# **APPENDIX A: Facility Reports**

City Hall - Exterior  
 2600 Fresno Street, Fresno

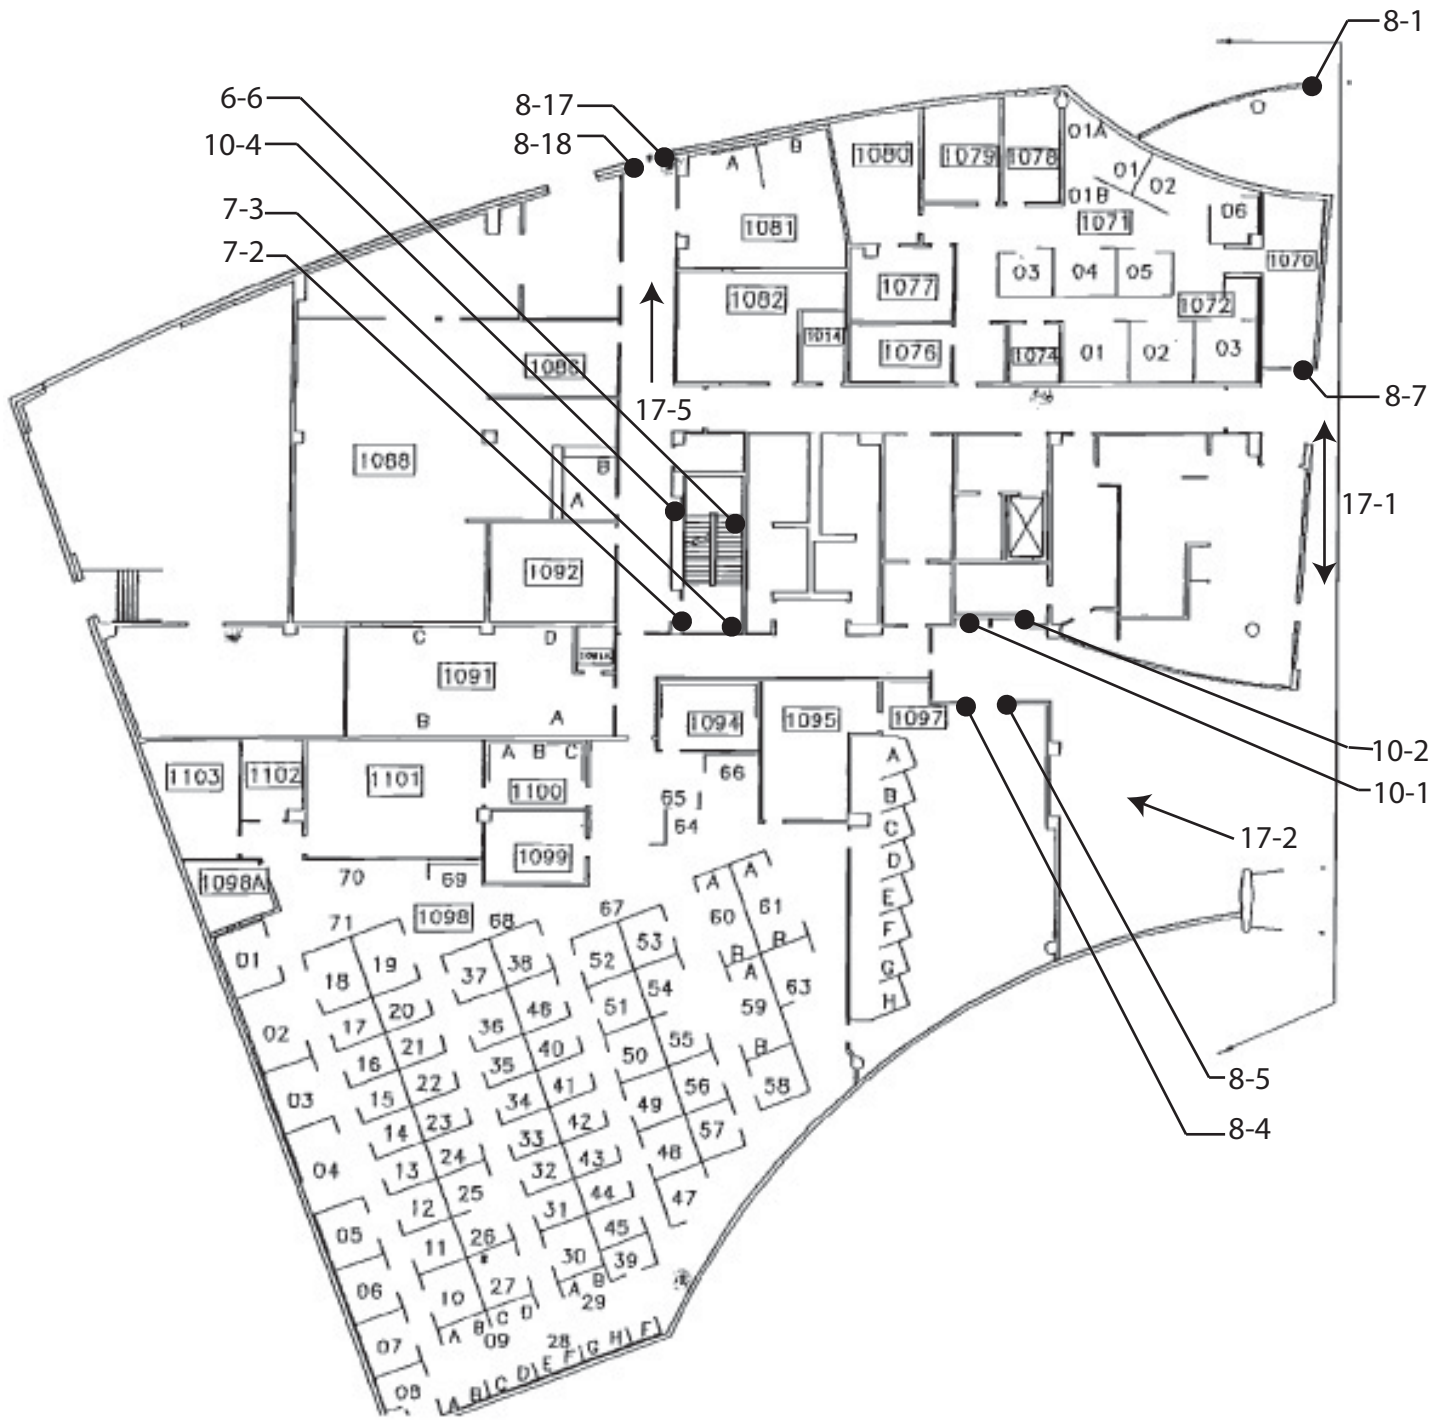
<b>Exterior</b>	
<b>1 - 1</b>	<b>Parking Area</b> <span style="float: right;">Priority: C</span>
<b>Provide an accessible path of travel</b>	<b>\$2,000</b>
Notes: Accessible route to the parking area is not provided.	
State: 1114B.1.2, 1129B.3 #3	
Federal: 4.3.2	
<b>Install sign</b>	<b>\$100</b>
Notes: The words 'NO PARKING' are not painted in each access aisle.	
State: 1129B.3 #1, 1129B.3 #2	
Federal: -	
<b>Install van parking sign</b>	<b>\$250</b>
Notes: Van accessible parking signage is not provided.	
State: 1129B.4	
Federal: 4.6.4	
<b>Provide or modify accessible spaces</b>	<b>\$2,550</b>
Notes: There are a total of 87 parking spaces and only 3 accessible parking spaces (4 required, including 1 van accessible stall).	
State: 1129B	
Federal: 4.1.2(5)(b)	
<b>Provide or modify accessible spaces</b>	<b>\$750</b>
Notes: Stall length is 16' (18' min). Stall width is 8'7" (9' min).	
State: 1129B.4 #1	
Federal: 4.6.3

<b>Provide or modify accessible access aisles</b>	<b>\$150</b>
Notes: Access aisle width is 65" (96" min for access aisle designated for vans).	
State: 1129B.3 #2	
Federal: 4.6.3	
<b>Regrade surface</b>	<b>\$1,800</b>
Notes: Slope in access aisle is 7% (2% max) due to built-up curb ramp.	
State: 1129B.3 #4	
Federal: 4.6.3

<b>Exterior</b>	
<b>1 - 2</b>	<b>Parking Area</b> <span style="float: right;">Priority: 4</span>
<b>Provide an accessible path of travel</b>	<b>\$1,680</b>
Notes: Accessible route to the building entrance is not provided. Wheelchair users are required to walk behind other parked vehicles to access building entrance. Distance from parking stall to curb ramp is 41-1/2".	
State: 1114B.1.2, 1129B.3 #3	
Federal: 4.3.2	
<b>Install sign</b>	<b>\$50</b>
Notes: The words 'NO PARKING' are not painted in the access aisle.	
State: 1129B.3 #1, 1129B.3 #2	
Federal: -	
<b>Install van parking sign</b>	<b>\$250</b>
Notes: Van accessible parking signage is not provided.	
State: 1129B.4	
Federal: 4.6.4	
<b>Install sign for unauthorized parking</b>	<b>\$400</b>
Notes: Warning sign is not provided.	
State: 1129B.4, 1133B.8.6.3	
Federal: -	
<b>Provide or modify accessible spaces</b>	<b>\$2,550</b>
Notes: There is a total of 73 parking spaces and only 2 accessible stalls (3 required, including 1 van accessible stall).

Exterior	
1 - 3	Parking Area
Priority: 4	
<b>Provide an accessible path of travel</b>	<b>\$2,000</b>
Notes: Accessible route to the parking area is not provided.	
State: 1114B.1.2, 1129B.3 #3	
Federal: 4.3.2	
<b>Install sign</b>	<b>\$100</b>
Notes: The words 'NO PARKING' are not painted in each access aisle.	
State: 1129B.3 #1, 1129B.3 #2	
Federal: -	
<b>Install van parking sign</b>	<b>\$250</b>
Notes: Van accessible parking signage is not provided.	
State: 1129B.4	
Federal: 4.6.4	
<b>Provide or modify accessible spaces</b>	<b>\$5,100</b>
Notes: There are a total of 124 parking spaces and only 3 accessible parking spaces (5 required, including 1 van accessible stall).	
State: 1129B	
Federal: 4.1.2(5)(b)	
<b>Provide or modify accessible spaces</b>	<b>\$750</b>
Notes: Stall width is 8'7" (9' min). Stall length is 16' (18' min).	
State: 1129B.4 #1	
Federal: 4.6.3	
<b>Provide or modify accessible access aisles</b>	<b>\$150</b>

Notes: Access aisle width is 65" (96" min for access aisle designated for vans).	
State: 1129B.3 #2	
Federal: 4.6.3	
<b>Regrade surface</b>	<b>\$1,800</b>
Notes: Slope in access aisle is 9.4% (2% max) due to built-up curb ramp.	
State: 1129B.3 #4	
Federal: 4.6.3

<b>Exterior</b>	
<b>3 - 1</b>	<b>Curb Ramp</b> <span style="float: right;">Priority: 1</span>
<b>Provide surface texturing</b>	\$300
Notes: Surface material does not contrast with surrounding sidewalks.	
State: 1127B.5 #5	
Federal: -	
<b>Provide detectable warning strip</b>	\$1,000
Notes: Detectable warning strips are not provided.	
State: 1127B.5 #7	
Federal: 4.7.7	
<b>3 - 2</b>	<b>Curb Ramp</b> <span style="float: right;">Priority: 1</span>
<b>Provide detectable warning strip</b>	\$1,000
Notes: Detectable warning strips are not provided.	
State: 1127B.5 #7	
Federal: 4.7.7	
<b>3 - 3</b>	<b>Curb Ramp</b> <span style="float: right;">Priority: 1</span>
<b>Provide detectable warning strip</b>	\$1,000
Notes: Detectable warning strips are not provided.	
State: 1127B.5 #7	
Federal: 4.7.7	
<b>3 - 4</b>	<b>Curb Ramp</b> <span style="float: right;">Priority: C</span>
<b>Provide detectable warning strip</b>	\$1,000
Notes: Detectable warning strips are not provided.

<b>Exterior</b>		
<b>3 - 5</b>	<b>Curb Ramp</b>	Priority: C
<b>Provide detectable warning strip</b>		\$1,000
Notes: Detectable warning strips are not provided.		
State: 1127B.5 #7		
Federal: 4.7.7		
<b>Repair surface</b>		\$250
Notes: Surface level change is 5" (1/4" max).		
State: 1133B.7.4		
Federal: 4.7.2		
<b>Provide surface texturing</b>		\$300
Notes: Grooved borders are not provided.		
State: 1127B.5 #6		
Federal: 4.7.4		
<b>Install, replace or modify curb ramp</b>		\$2,500
Notes: Built up curb ramp located in access aisle. Remove built-up curb ramp.		
State: 1129B.5 #1		
Federal: 4.7.6		
<b>3 - 6</b>	<b>Curb Ramp</b>	Priority: 4
<b>Repair surface</b>		\$250
Notes: Surface level change is 5" (1/4" max).		
State: 1133B.7.4		
Federal: 4.7.2		
<b>Install, replace or modify curb ramp</b>		\$2,500
Notes: Built up curb ramp located in access aisle. Slope of curb ramp is 9.4% (8.33% max).		
State: 1127B.5 #3, 1129B.5 #1

Federal: 4.7.6, 4.8.2		
<b>3 - 7</b>	<b>Curb Ramp</b>	Priority: 4
<b>Provide detectable warning strip</b>		\$1,000
Notes: Detectable warning strips are not provided.		
State: 1127B.5 #7		
Federal: 4.7.7		
<b>4 - 1</b>	<b>Walk</b>	Priority: 1
<b>Regrade surface</b>		\$10,000
Notes: Cross slope is 4% (2% max).		
State: 1133B.7.1.3		
Federal: 4.3.7

<b>Exterior</b>		
<b>4 - 2</b>	<b>Walk</b>	Priority: 1
<b>Regrade surface</b>		\$10,000
Notes: Cross slope is 2.3% (2% max).		
State: 1133B.7.1.3		
Federal: 4.3.7		
<b>5 - 1</b>	<b>Ramp</b>	Priority: 4
<b>Install or modify handrails</b>		\$2,000
Notes: Handrails are not provided.		
State: 1133B.5.5.1		
Federal: 4.26.2, 4.26.4, 4.8.5 #1, 4.8.5 #2, 4.8.5 #3, 4.8.5 #5, 4.8.5 #6, 4.8.5 #7		
<b>5 - 2</b>	<b>Ramp</b>	Priority: 1
<b>Install or modify handrails</b>		\$2,000
Notes: Handrails are not provided.		
State: 1133B.5.5.1		
Federal: 4.26.2, 4.26.4, 4.8.5 #1, 4.8.5 #2, 4.8.5 #3, 4.8.5 #5, 4.8.5 #6, 4.8.5 #7		
<b>6 - 1</b>	<b>Stairway</b>	Priority: 4
<b>Install tread striping</b>		\$270
Notes: Indicator stripes are 1-3/4" (2" min) wide. Indicator stripes are positioned within 1" of the edge of the nosing.		
State: 1127B.4, 1133B.4.4		
Federal: -		
<b>Replace stairs</b>		\$6,750
Notes: Risers are 3-3/4" to 4" (4" to 7" max) high.

State: 1009.3		
Federal: -		
<b>Install or modify handrails</b>		\$2,000
Notes: Handrail top surface is mounted 33" (34" to 38" max) above the stair nosing. Handrail diameter is 1-3/4" (1-1/4" to 1-1/2").		
State: 1133B.4.2.1, 1133B.4.2.6		
Federal: 4.26.2, 4.9.4 #5

<b>Exterior</b>		
<b>6 - 2</b>	<b>Stairway</b>	Priority: 4
<b>Install tread striping</b>		\$30
Notes: Indicator stripes are 1-3/4" (2" min) wide.		
State: 1127B.4, 1133B.4.4		
Federal: -		
<b>Replace stairs</b>		\$10,000
Notes: Risers are 3-3/4" (4" to 7" max) high.		
State: 1009.3		
Federal: -		
<b>Install or modify handrails</b>		\$2,000
Notes: Handrail top surface is mounted 33" (34" to 38" max) above the stair nosing. Handrail diameter is 1-3/4" (1-1/4" to 1-1/2"). Handrail is 1-3/4" (1-1/2") from the wall.		
State: 1133B.4.2.1, 1133B.4.2.5, 1133B.4.2.6		
Federal: 4.26.2, 4.9.4 #3, 4.9.4 #5		
<b>6 - 3</b>	<b>Stairway</b>	Priority: 4
<b>Install or modify handrails</b>		\$2,000
Notes: Handrail with continuous gripping surfaces is only provided on one side. Extension at the top of the stair is not provided. Handrail diameter is 1-3/4" (1-1/4" to 1-1/2"). Handrail is 1-3/4" (1-1/2") to the wall.		
State: 1133B.4.1.1, 1133B.4.2.2, 1133B.4.2.5, 1133B.4.2.6

Federal: 4.26.2, 4.9.4, 4.9.4 #2, 4.9.4 #3		
<b>6 - 4</b>	<b>Stairway</b>	Priority: 1
<b>Install or modify handrails</b>		\$2,000
Notes: Handrail diameter is 1-3/4" (1-1/4" to 1-1/2"). Handrail is 7-3/4" (1-1/2") to the wall.		
State: 1133B.4.2.5, 1133B.4.2.6		
Federal: 4.26.2, 4.9.4 #3		
<b>34 - 1</b>	<b>Fixed Bench</b>	Priority: 4
<b>Provide accessible fixed bench</b>		\$900
Notes: Back support is not provided. Armrests are not provided.		
State: -		
Federal: -		
<b>Increase or provide maneuvering or clear floor area</b>		\$2,500
Notes: 30" x 48" min clear floor space is not provided at either end of the bench for companion seating due to bollards.		
State: -		
Federal: -

City Hall - North Wing - First Floor  
 2600 Fresno Street, Fresno

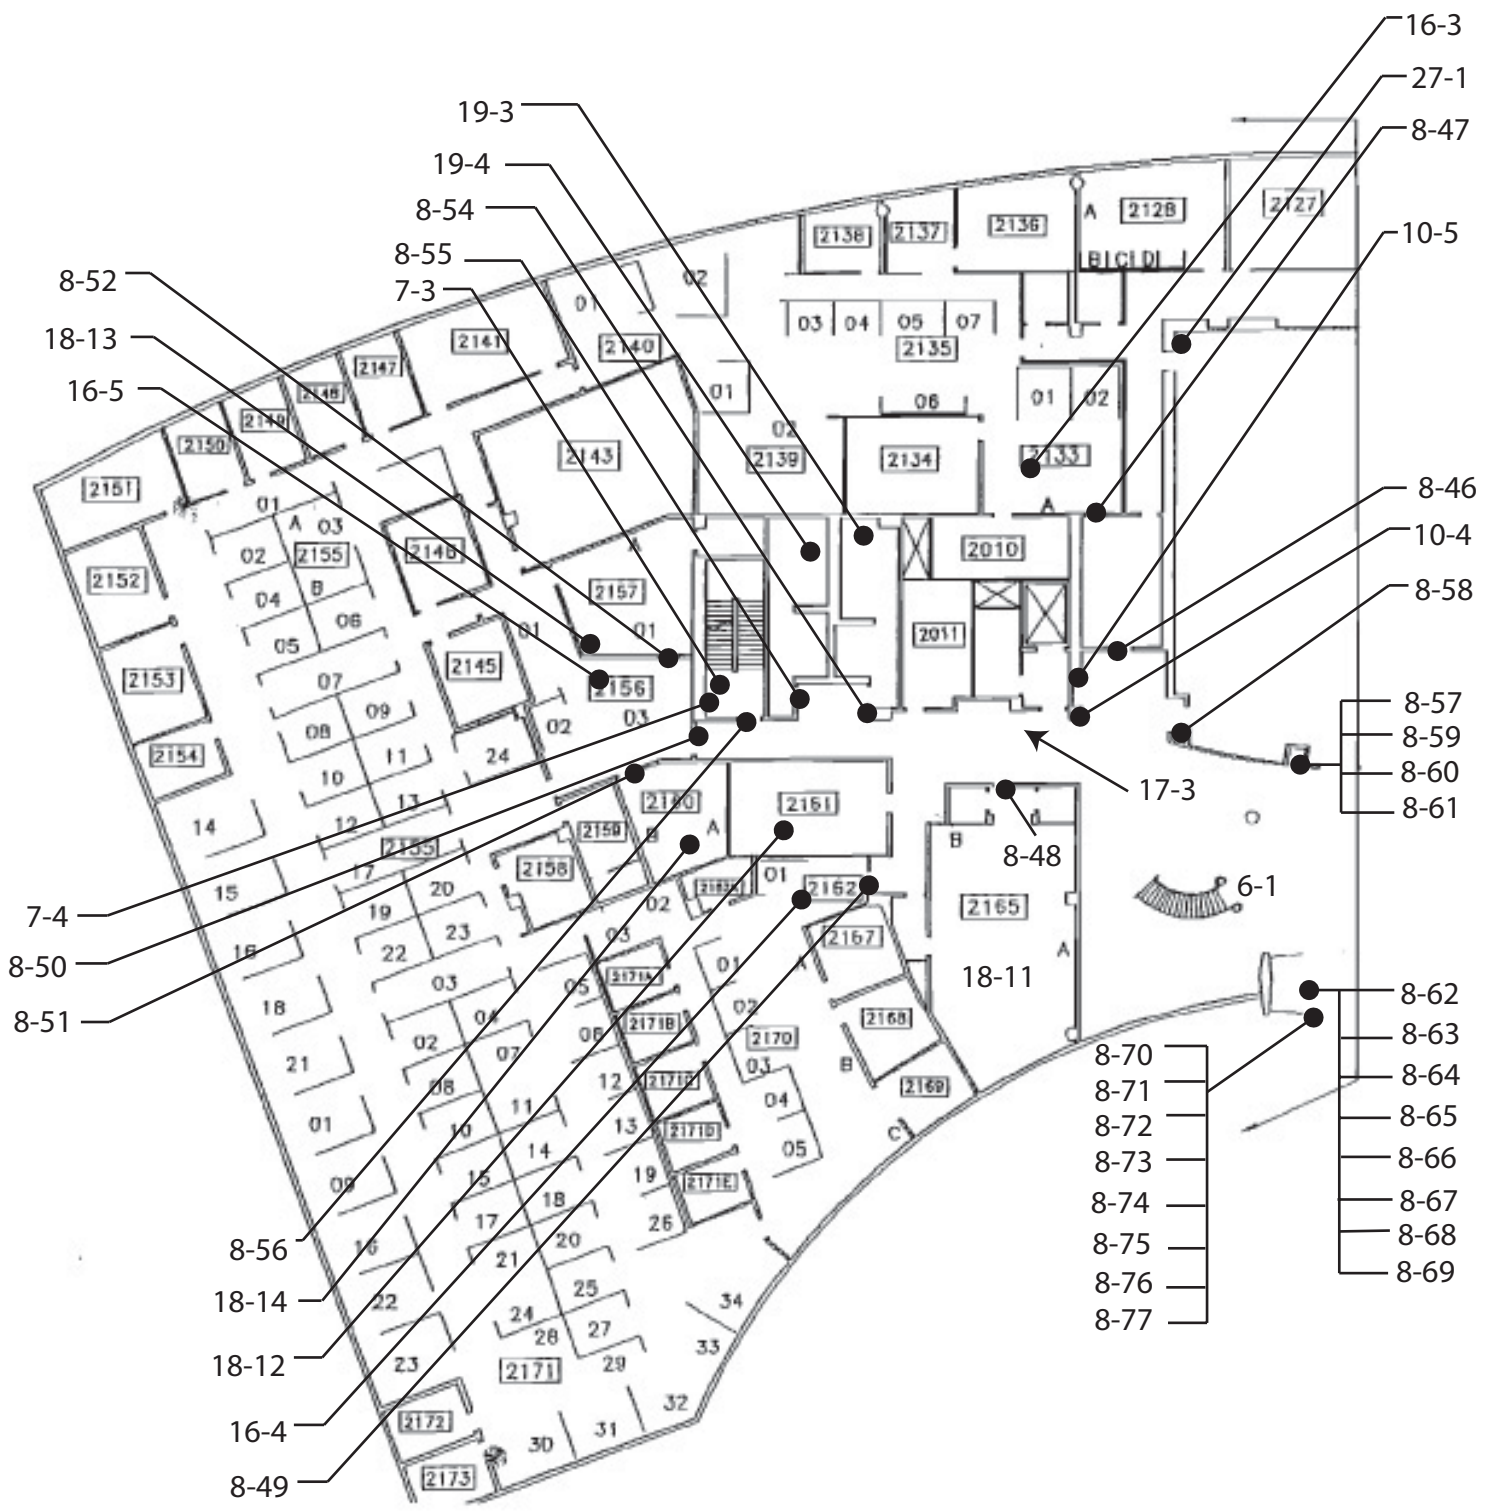
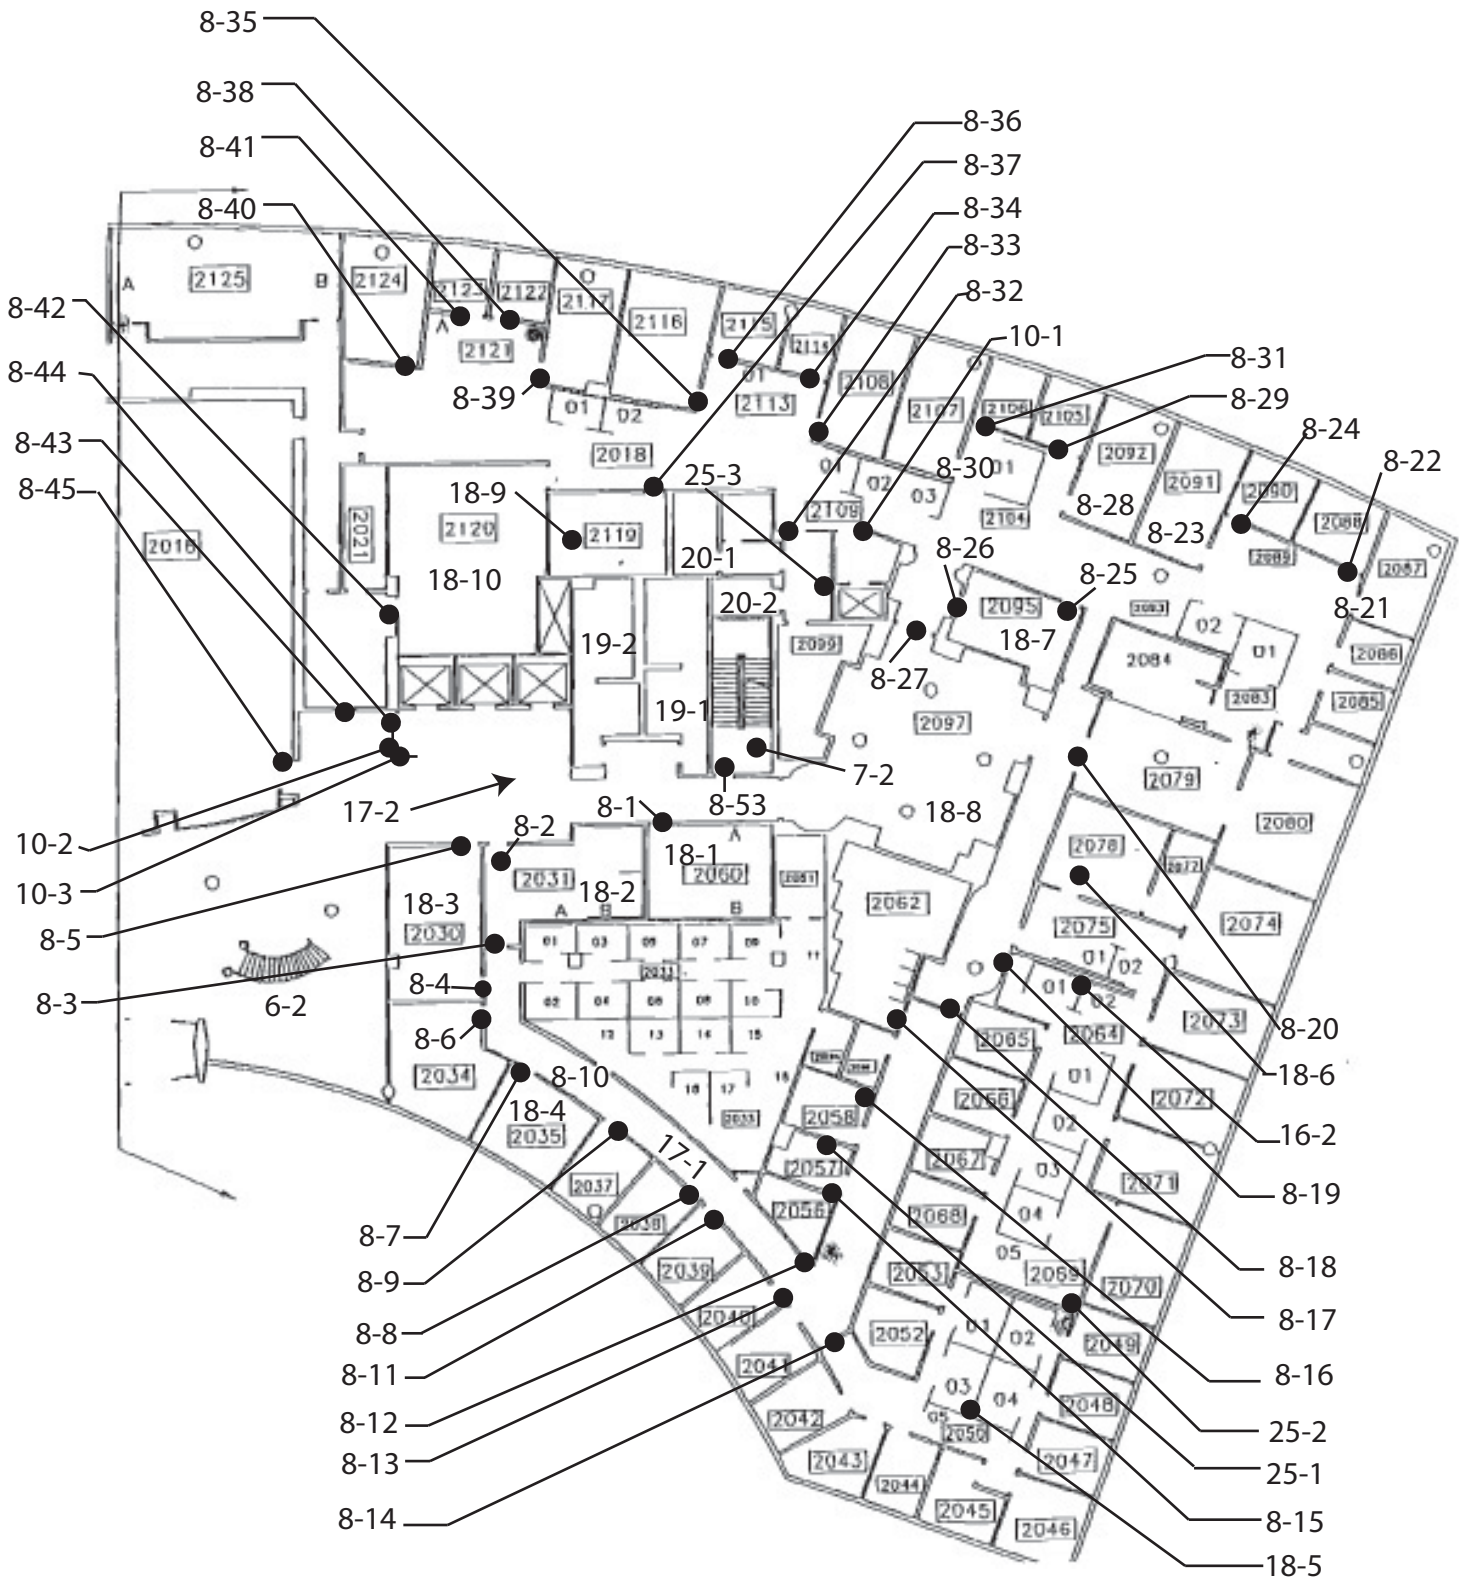
<b>Floor 1</b>		
<b>6 - 5</b>	<b>Stairway</b>	Priority: 4
<b>Install tread striping</b>		\$30
Notes: Indicator stripes are not provided.		
State: 1133B.4.4		
Federal: -		
<b>6 - 6</b>	<b>Stairway</b>	Priority: 4
<b>Install tread striping</b>		\$30
Notes: Indicator stripes are not provided.		
State: 1133B.4.4		
Federal: -		
<b>7 - 1</b>	<b>Hazard</b>	Priority: 4
<b>Remove overhanging or protruding objects</b>		\$100
Notes: Standpipe protrudes 21" (4" max) and is 27-1/2" (not between 27" to 80") above the finished floor.		
State: 1133B.8.6.1		
Federal: 4.4.1		
<b>7 - 2</b>	<b>Hazard</b>	Priority: 4
<b>Remove overhanging or protruding objects</b>		\$100
Notes: Standpipe protrudes 21" (4" max) and is 27-1/2" (not between 27" to 80") above the finished floor.		
State: 1133B.8.6.1		
Federal: 4.4.1		
<b>7 - 3</b>	<b>Hazard</b>	Priority: 4
<b>Remove overhanging or protruding objects</b>		\$100
Notes: Pipe is 73-1/2" (80" min) above the finished floor.

<b>Floor 1</b>	
<b>8 - 17 Door/Gate</b>	Priority: 4
<b>Adjust door closer</b>	\$100
Notes: Operating effort is 14 lbs (5 lbs max).	
State: 1133B.2.5	
Federal: 4.13.11	
<b>Install or modify permanent room signs</b>	\$250
Notes: Braille is not provided.	
State: -	
Federal: 1117B.5.7, 4.30.6	
<b>8 - 18 Door/Gate</b>	Priority: 4
<b>Adjust door closer</b>	\$100
Notes: Operating effort is 9 lbs (5 lbs max).	
State: 1133B.2.5	
Federal: 4.13.11	
<b>10 - 1 Drinking Fountain</b>	Priority: 3
<b>Replace or reposition drinking fountain</b>	\$3,500
Notes: Depth is 9-1/2" (18" min). "Hi-lo" fountain is not provided.	
State: 1115B.4.6 #1, 1117B.4.6 #2	
Federal: 4.1.6, 4.15.5	
<b>10 - 2 Drinking Fountain</b>	Priority: 4
<b>Replace or reposition drinking fountain</b>	\$3,500
Notes: Depth is 9-1/2" (18" min).	
State: 1115B.4.6 #1, 1117B.4.6 #2	
Federal: 4.1.6, 4.15.5	
<b>10 - 3 Drinking Fountain</b>	Priority: 4
<b>Replace or reposition drinking fountain</b>	\$5,000

Notes: Depth is 9-1/2" (18" min). "Hi-lo" fountain is not provided.	
State: 1115B.4.6 #1, 1117B.4.6 #2	
Federal: 4.1.6, 4.15.5	
<b>10 - 4 Drinking Fountain</b>	Priority: 4
<b>Replace or reposition drinking fountain</b>	\$5,000
Notes: Depth is 10" (18" min). Height is 26" (27" min). "Hi-lo" fountain is not provided.	
State: 1115B.4.6 #1, 1115B.4.6 #2, 1117B.4.6 #2	
Federal: 4.1.6, 4.15.5

Notes: Transaction counter is 40-1/2" (28" to 34") above the finished floor.	
State: 1122B.5	
Federal: 4.32.4	
<b>16 - 2 Transaction Counter</b>	Priority:4
<b>Provide an accessible counter</b>	\$4,000
Notes: Transaction counter is 45-1/2" (28" to 34") above the finished floor.	
State: 1122B.5	
Federal: 4.32.4

<b>Floor 1</b>	
<b>19 - 1 Multiple User Restroom</b>	<b>Priority:2</b>
<b>Provide or replace stall door hardware</b>	<b>\$100</b>
Notes: Stall door is not self-closing. U-shaped handle is not provided on the back side of stall door.	
State: 1115B.3.1 #4.5	
Federal: 4.13.9	
<b>Reposition toilet flush controls</b>	<b>\$750</b>
Notes: Flush control is not located on the wide side.	
State: 1115B.4.1 #5	
Federal: 4.16.5	
<b>Modify lavatory/counter clearances</b>	<b>\$3,500</b>
Notes: Height of counter is 36" (34" max) above the finished floor. Lower lavatory.	
State: 1115B.4.3 #2	
Federal: 4.19.2	
<b>Modify stall partitions and doors</b>	<b>\$800</b>
Notes: Door width for side-entry stall is 33-1/2" (34" min).	
State: 1115B.3.1 #4.4	
Federal: -	
<b>Replace or reposition dispensers or mirrors</b>	<b>\$100</b>
Notes: Seat cover dispenser is 41" (40" max) above the finished floor.	
State: 1115B.8.3	
Federal: 4.23.7

<b>Floor 1</b>	
<b>19 - 2 Multiple User Restroom</b>	<b>Priority:2</b>
<b>Modify lavatory/counter clearances</b>	<b>\$3,500</b>
Notes: Height of counter is 36" (34" max) above the finished floor. Lower lavatory.	
State: 1115B.4.3 #2	
Federal: 4.19.2	
<b>Provide or replace stall door hardware</b>	<b>\$100</b>
Notes: Stall door is not self-closing. U-shaped handle is not provided on the back side of stall door.	
State: 1115B.3.1 #4.5	
Federal: 4.13.9	
<b>Modify stall partitions and doors</b>	<b>\$800</b>
Notes: Door width for side-entry stall is 33-1/2" (34" min).	
State: 1115B.3.1 #4.4	
Federal: -	
<b>Reposition toilet flush controls</b>	<b>\$750</b>
Notes: Flush control is not located on the wide side.	
State: 1115B.4.1 #5	
Federal: 4.16.5	
<b>Replace or reposition dispensers or mirrors</b>	<b>\$100</b>
Notes: Seat cover dispenser is 41" (40" max) above the finished floor.	
State: 1115B.8.3	
Federal: 4.23.7	
<b>25 - 1 Kitchen</b>	<b>Priority:3</b>

<b>Provide an accessible counter</b>	<b>\$4,000</b>
Notes: Countertop is located 36" (34" max) above the finished floor. Base cabinet directly under the sink does not provide clearance for a wheelchair.	
State: 1115B.4.7 #1	
Federal: 1115B.4.7 #1	
<b>Modify lavatory/counter clearances</b>	<b>\$3,500</b>
Notes: Height of counter is 36" (34" max) above the finished floor. Sink is 7" (6-1/2" max) deep. Provide an accessible sink.	
State: 1115B.4.7 #1	
Federal: 4.24.2, 4.24.4	
<b>Replace or reposition dispensers or mirrors</b>	<b>\$250</b>
Notes: Paper towel dispenser is 44" (40" max) above the finished floor.	
State: 1115B.9.2	
Federal: 4.23.7
